IN THE DRAWINGS:

REMARKS

FIG. 1

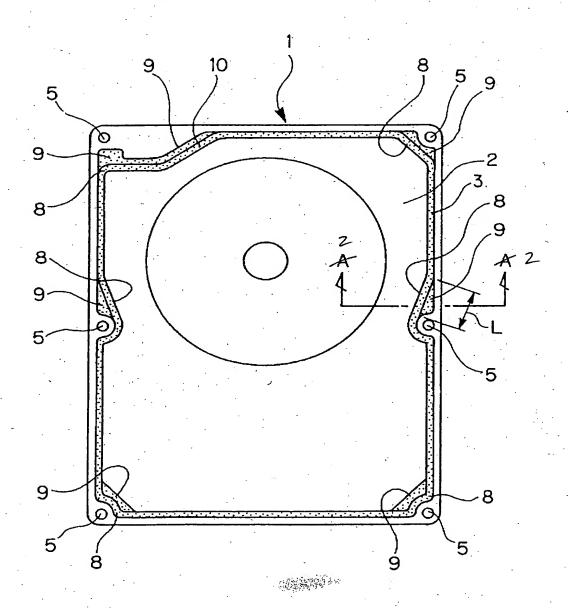
In the Office Action, the Examiner objected to the Figures 1 and 5-7 under 37 CFR 1.83(a). The specification was objected to under 35 U.S.C. 112, first paragraph, because of informalities. Claims 1-5 were rejected under 35 U.S.C. 112, second paragraph, as being indefinite. Claims 1-3 and 5 were rejected under 35 U.S.C. 103(a) as being unpatentable over Miyake et al. in Japanese Patent Application Publication No. JP 2003-049949 in view of any one of Shikano in U.S. Patent No. 5,568,341, Ishii et al. in Japanese Patent Application Publication No. JP 09-282860, or Nakada in Japanese Patent Application No. JP 05-326731. Claim 4 was rejected under 35 U.S.C. 103(a) as being unpatentable over Miyake et al. in Japanese Patent Application Publication No. JP 2003-049949 in view of any one of Shikano in U.S. Patent No. 5,568,341, Ishii et al. in Japanese Patent Application Publication No. JP 09-282860, or Nakada in Japanese Patent Application No. JP 05-326731 and further in view of Satoh et al. in U.S. Patent No. 6,623,684.

A Letter to the Official Draftsman is attached with proposed drawing corrections to Figures 1 and 5-7.

The attached sheets of drawings include changes to Figs. 1 and 5-7. These sheets, which include Figs. 1 and 5-7, replace the original sheets of Figs. 1 and 5-7.

FIG. 6

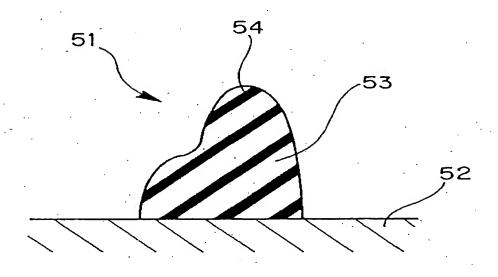
The shape of JP 2003-049949 is the same as the shape illustrated in Fig. 6, which is referred to as prior art in the present application. In JP 2003-049949, there is a packing overhang portion at the side opposite to a lip (right side on drawing) but no packing overhang portion at the side of the lip (left side on drawing).

On the other hand, in the present application, there are packing overhang portions not only at the side opposite to a lip (pouring hole side, right side on the drawing) but also at the side of the lip (left side on the drawing). This is the shape for a solution of the problem to be solved in the present application.
